Date: August 15, 2018
To: Cumberland Planning Board
From: Carla Nixon, Town Planner
Subject: OceanView at Cumberland Major Subdivision Final Review

Date August 15, 2018
To Town of Cumberland Planning Board
From Carla Nixon, Town Planner
Subject **Major 52 Unit Major Subdivision, Final Review: OceanView at Cumberland – 277 Tuttle Road**

Subject: Planner's Comments for Ocean View

PROGRESS PLAN NOT FOR CONSTRUCTION

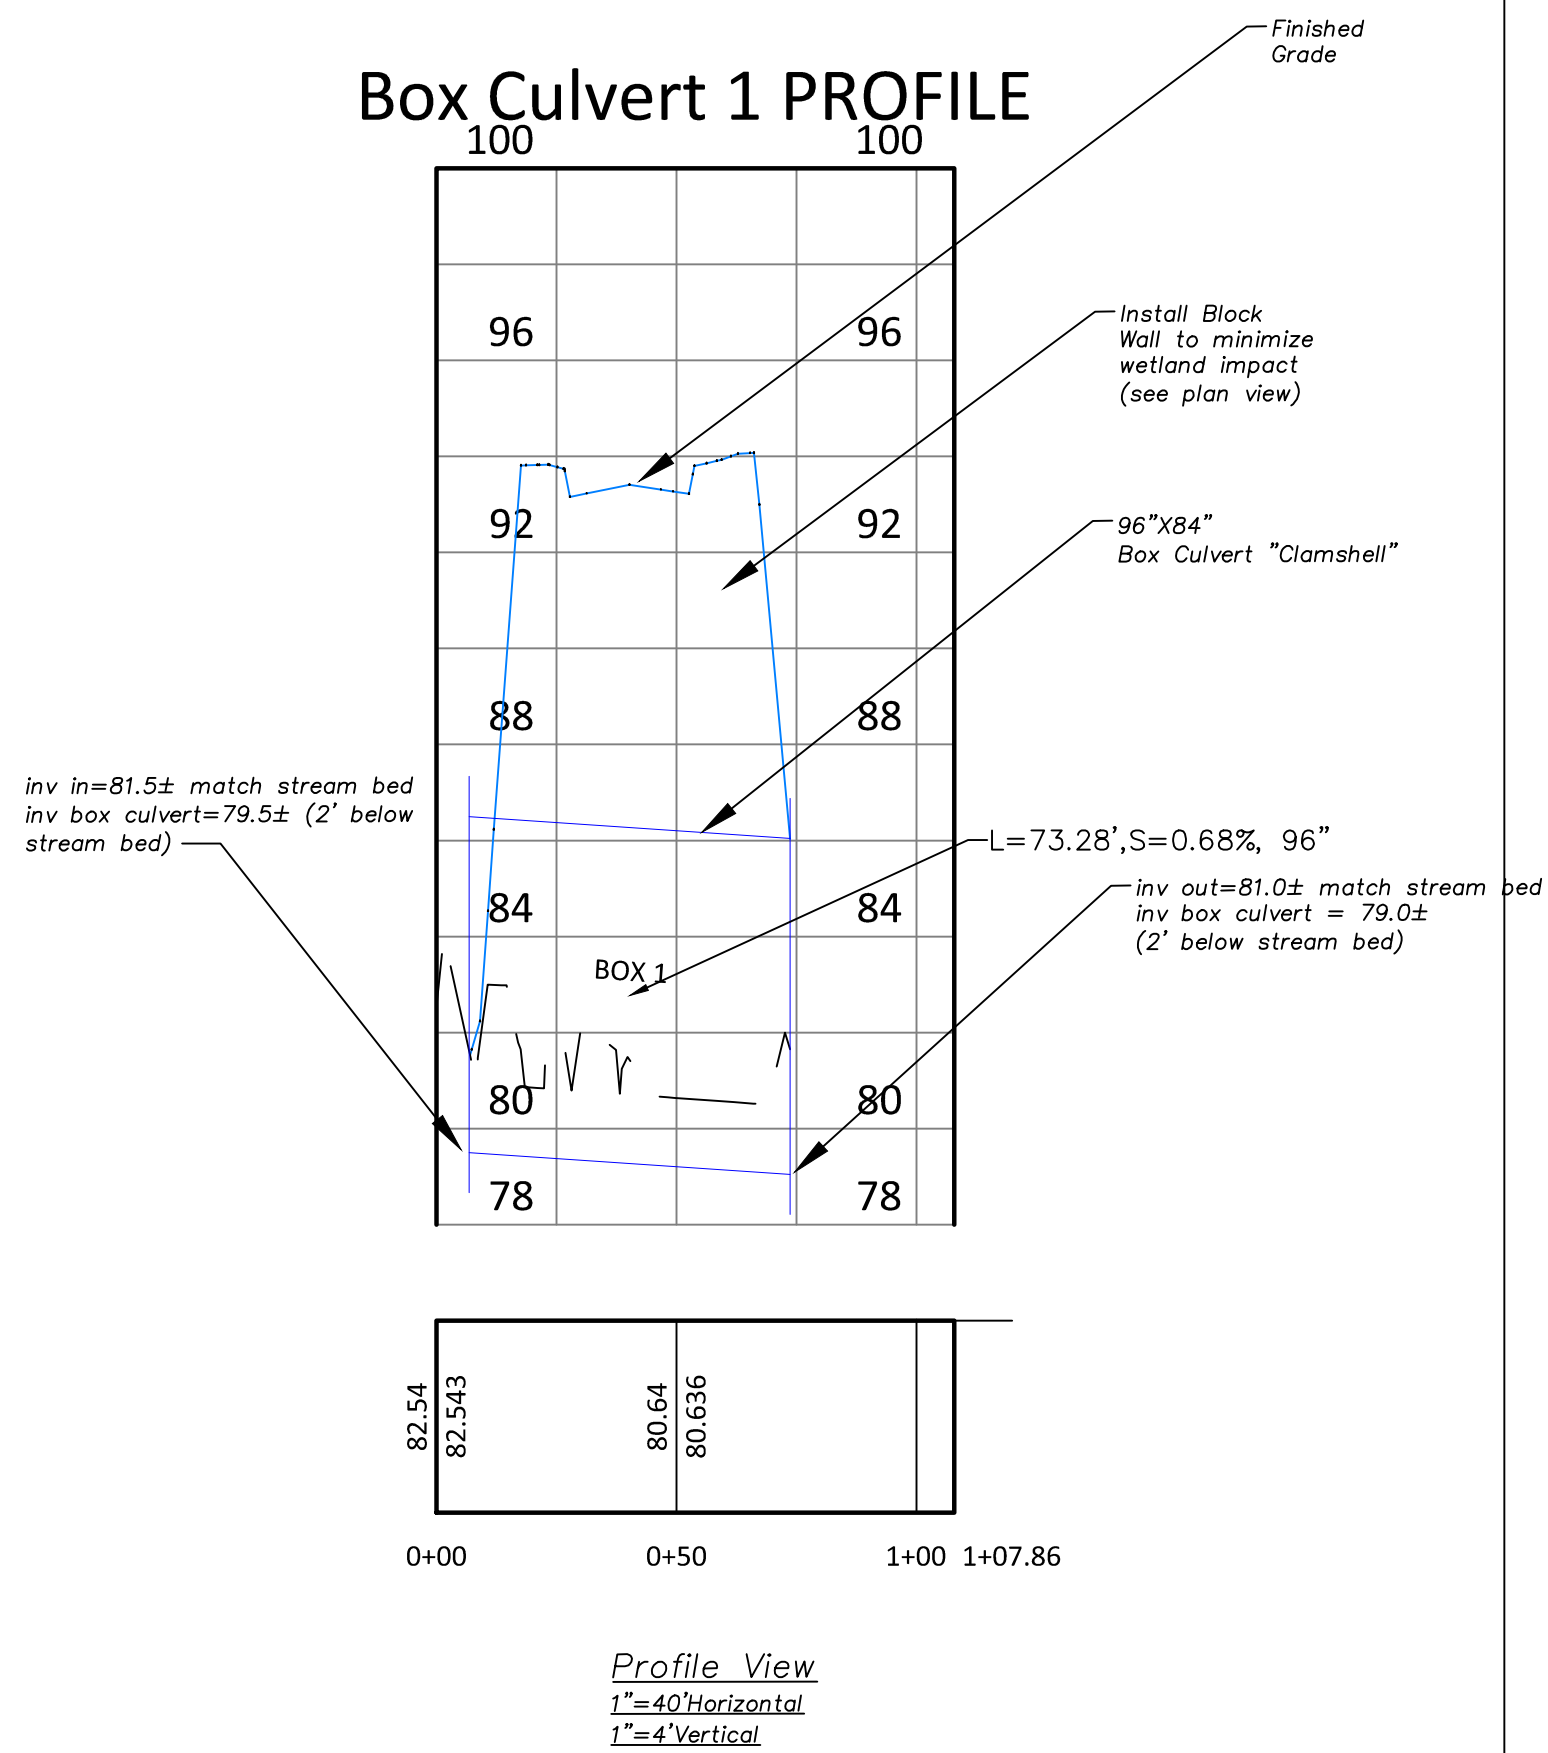
- Sheet C20 – The end view is of Box Culvert #2 not Box Culvert #1.

We have updated the end view on sheet C20.

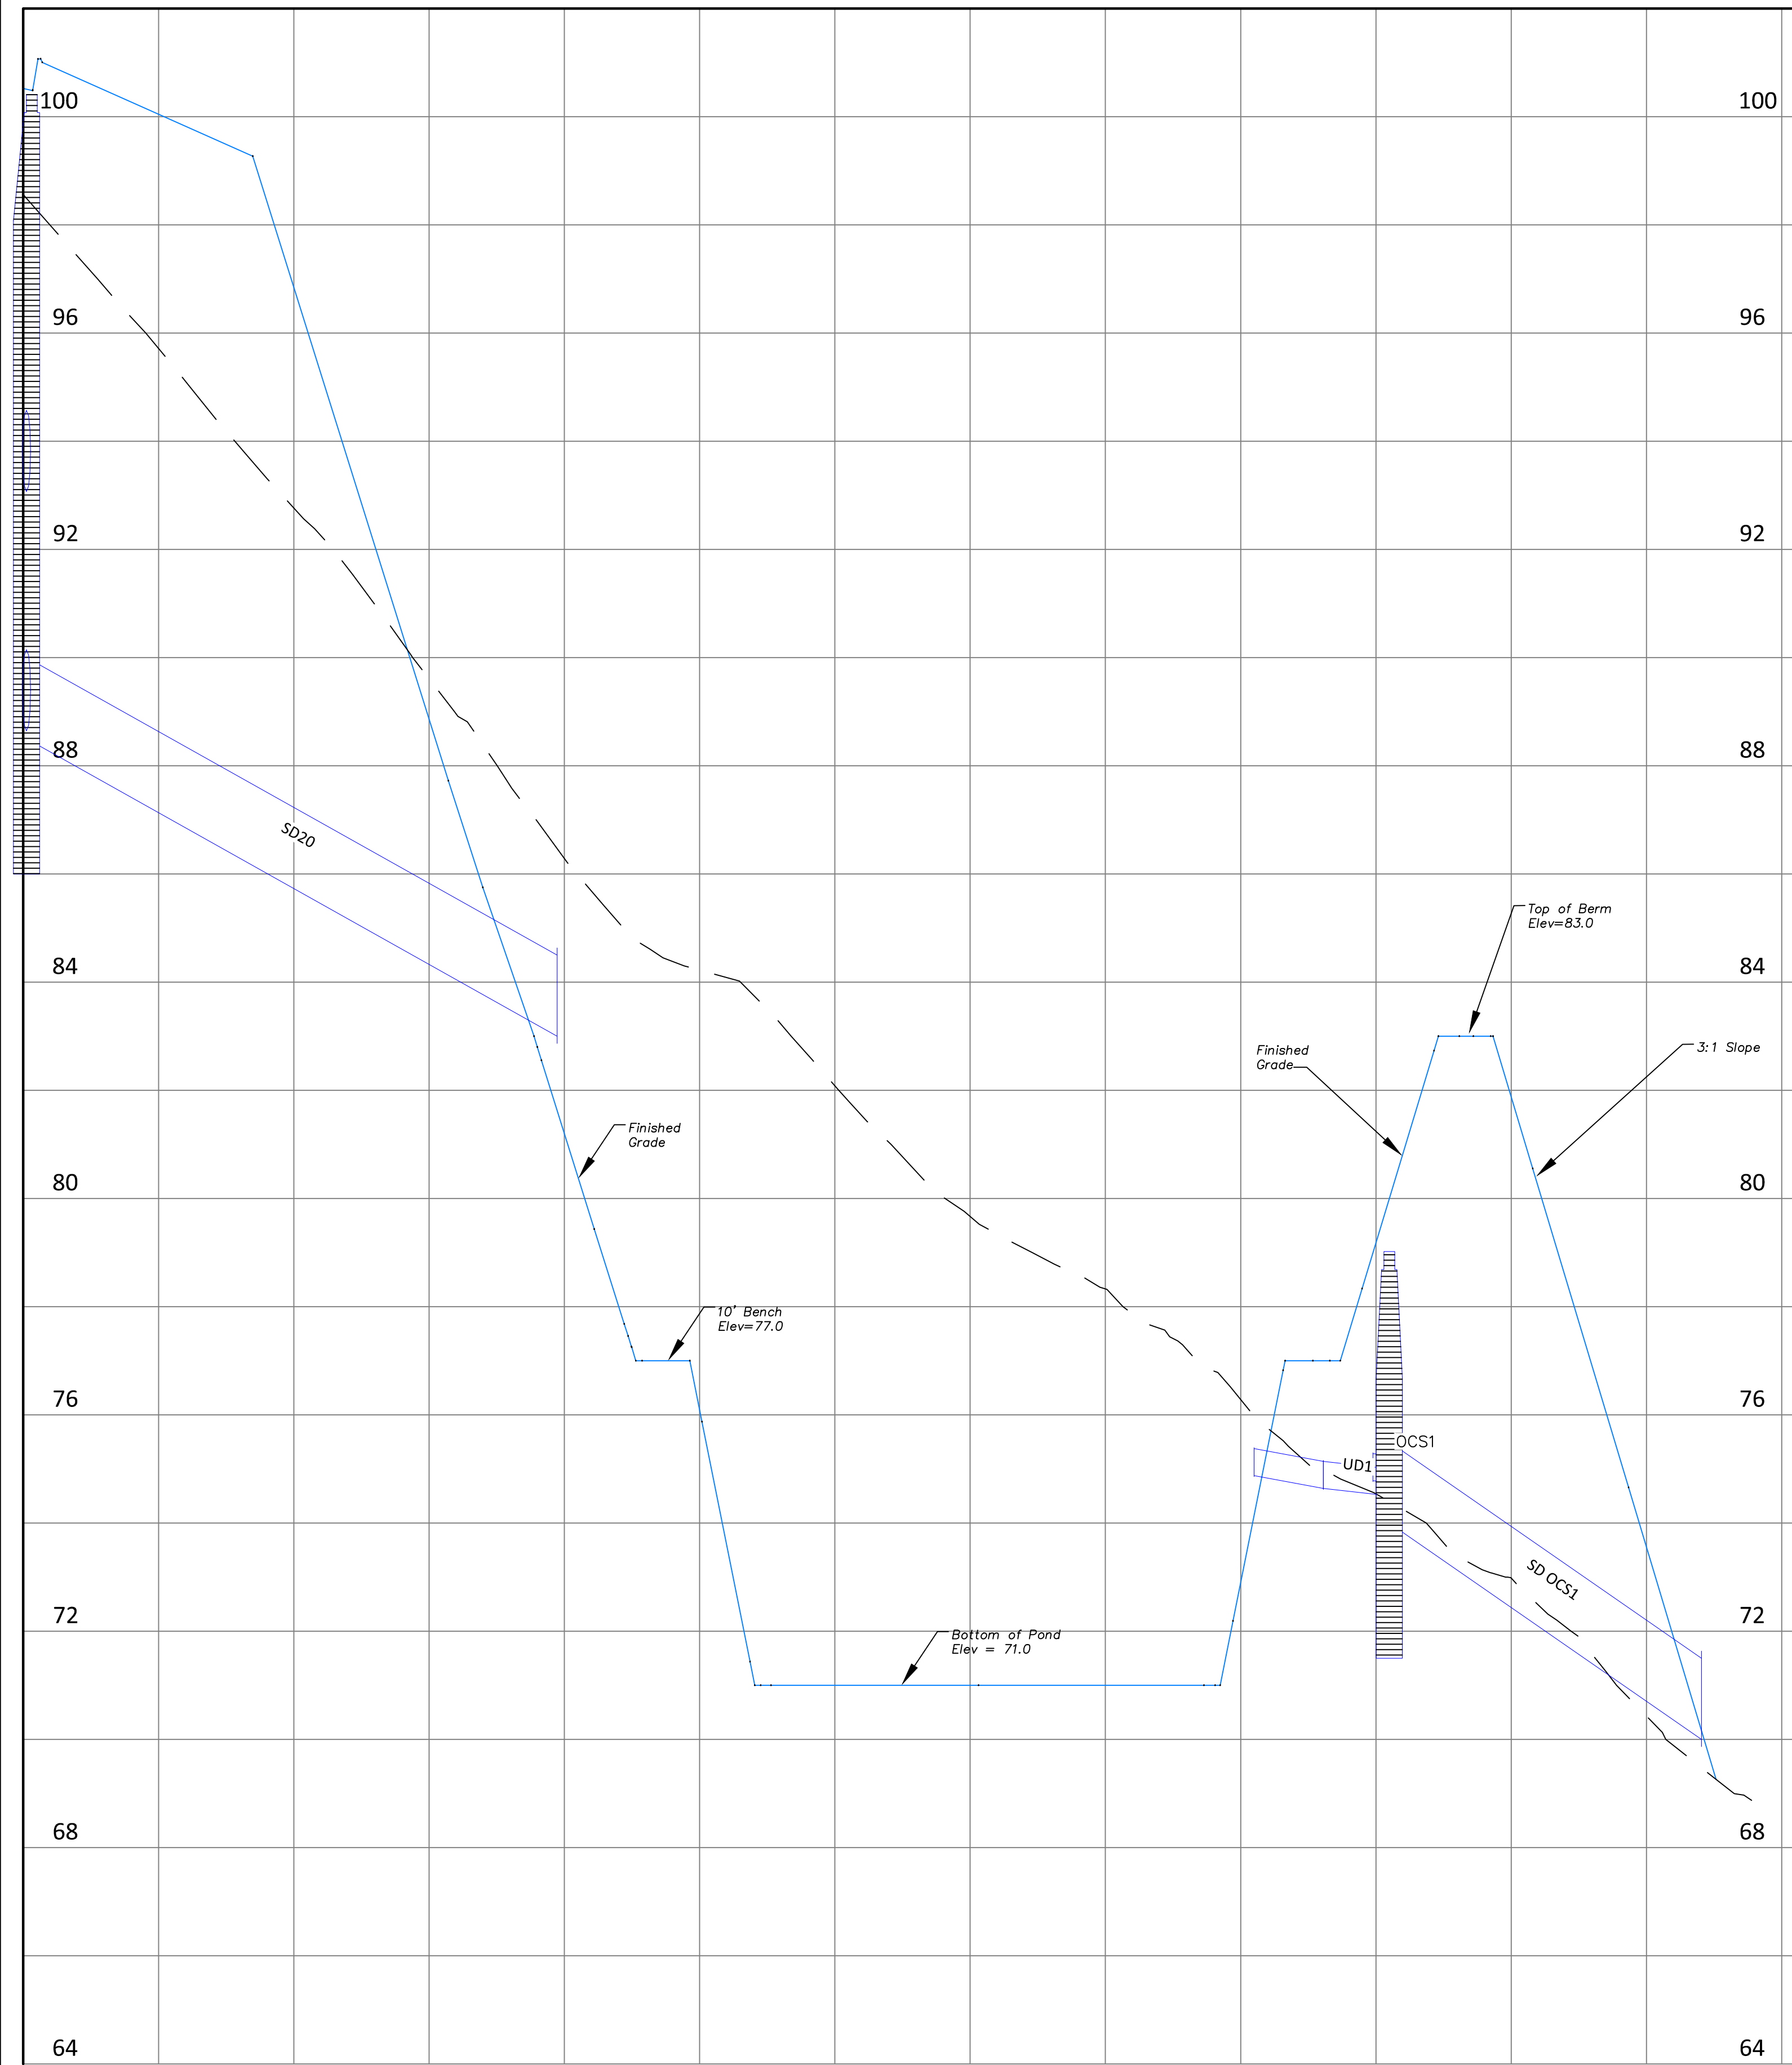
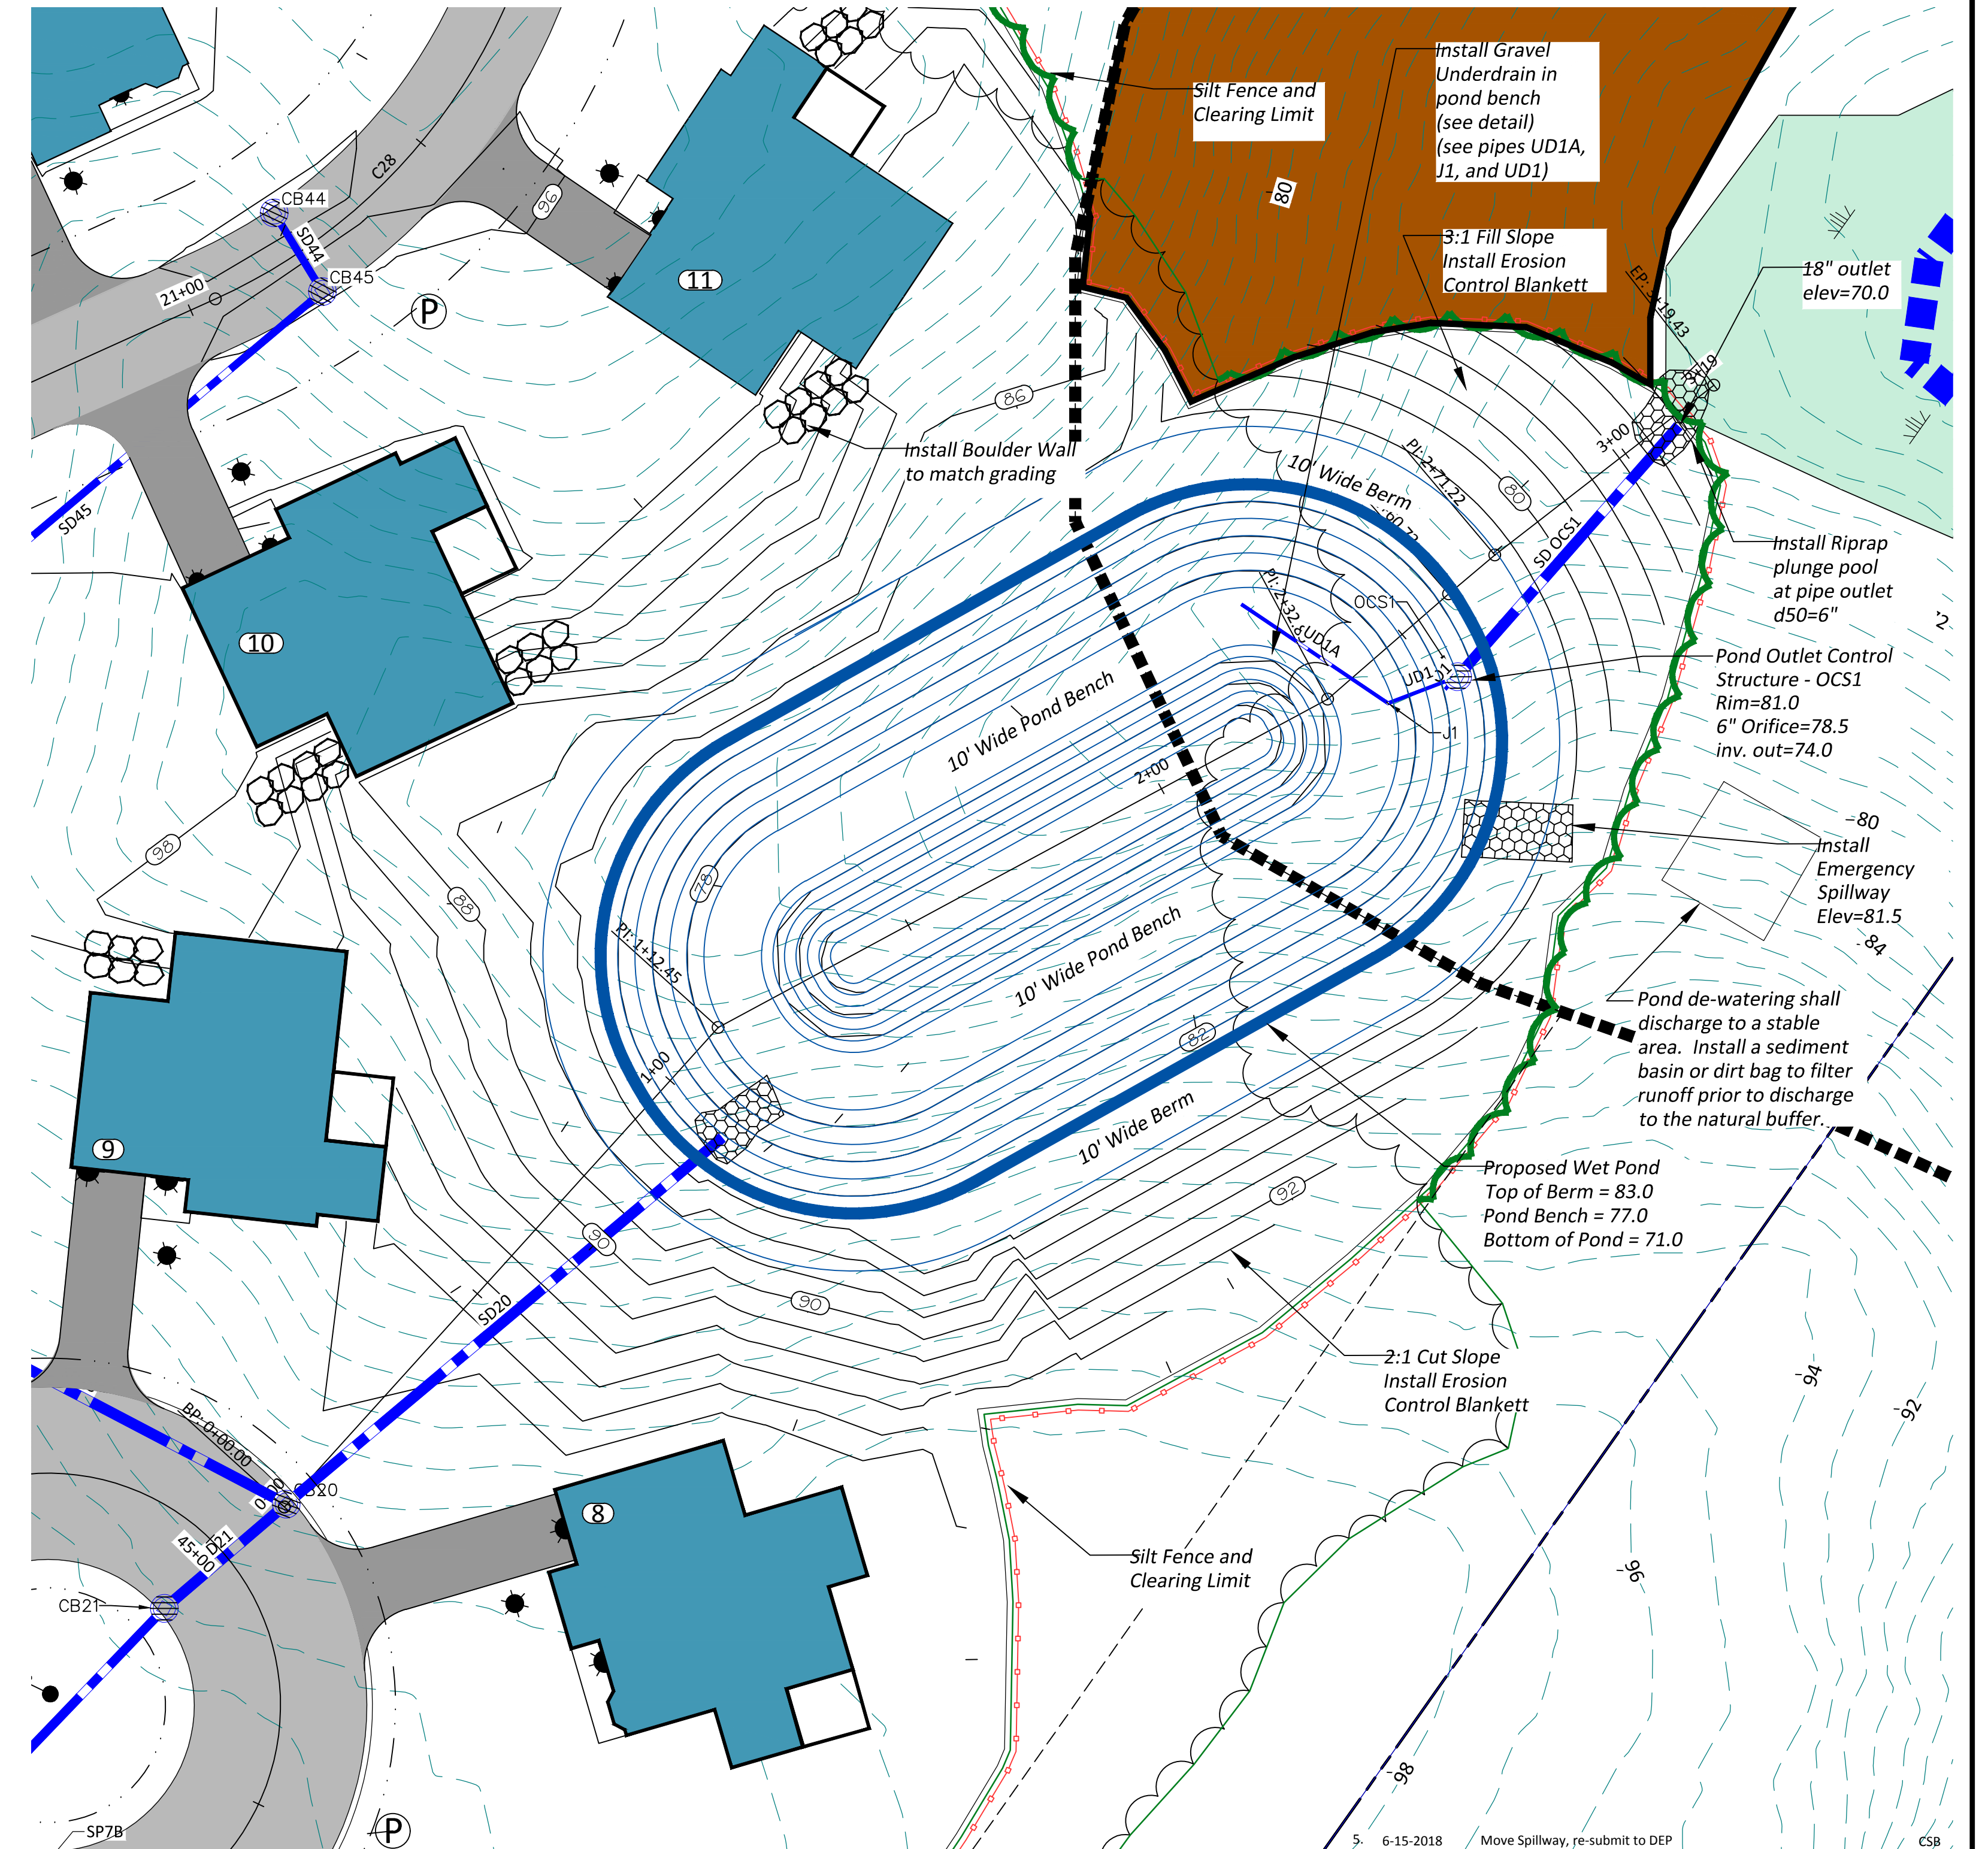
- Sheet C24 – The emergency spillway in the location proposed forces water from the spillway to make a 90 degree turn at the end of the spillway. Please investigate moving the emergency spillway to the other side of the principal outlet. In that location there would not be the abrupt change in direction.

We have moved the emergency spillway as requested. See Sheet C24.
